X 86.103-26

MODEL HUSQVARNA 50

AV-ELEMENTS

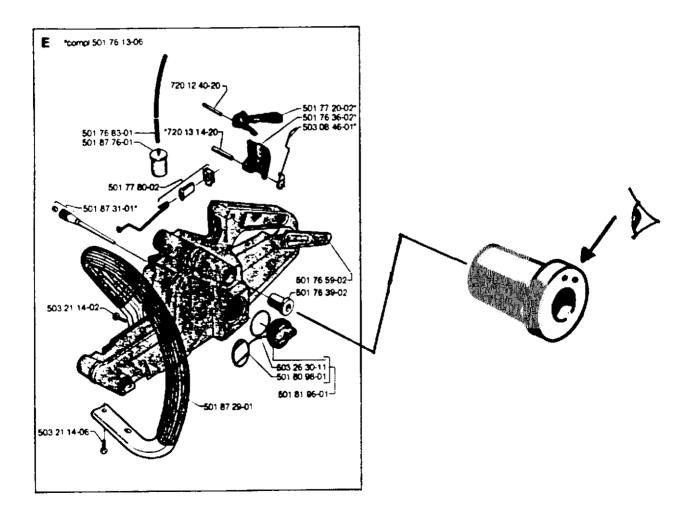
To make the saw more stable in use, we have increased the diameter of the AV-elements. Reference number same as before.

Introduced in production from serial number 6031101.

NOTE! The bigger AV-elements are marked with two dots.
